MEMORANDUM

Date: February 6, 2020
To: Design Commission
From: Hillary Adam, Design / Historic Review
 hillary.adam@portlandoregon.gov, 503-823-3581
Re: Briefing on River District ROW Standards
 February 13, 2020 Design Commission hearing

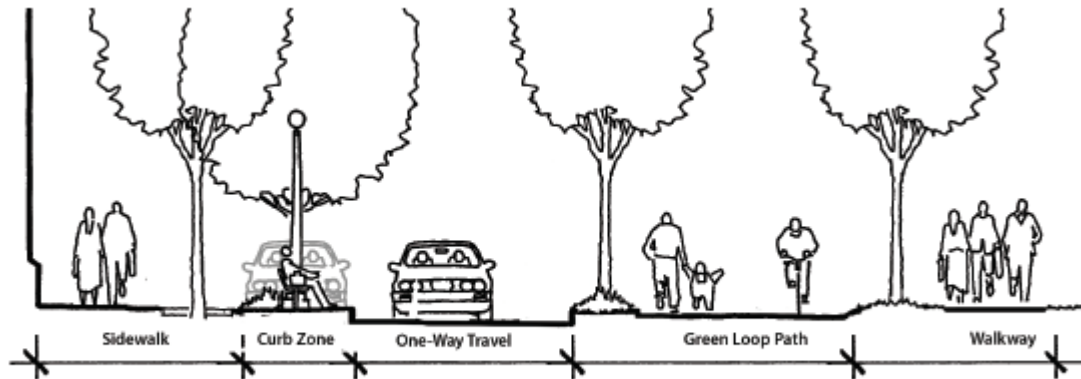
- **(pg. 36) Park Avenue NW Hoyt to Johnson dimensions.** The proposed sidewalk width on the west side of NW Park Avenue between Hoyt and Johnson is proposed to be 12', which would include the (1.5') frontage zone, (6') pedestrian through zone, (4') furnishing zone and (.5') curb zone. This is consistent with the rest of Park Avenue to the south. However, staff notes that along the Park Blocks to the south, no sidewalk café permits exist except at the Art House which has a 3' ground floor setback. In order to increase activation and safety of the park, wider sidewalks with space for outdoor dining is desirable.

Widening the sidewalk at this location, however, would have ripple effects on the rest of Park Avenue between Hoyt and Johnson as well as the open space proposed within the USPS Broadway Corridor Master Plan area; this complex issue is discussed in the staff report for LU 19-246279 CCMSAD, which you also received.
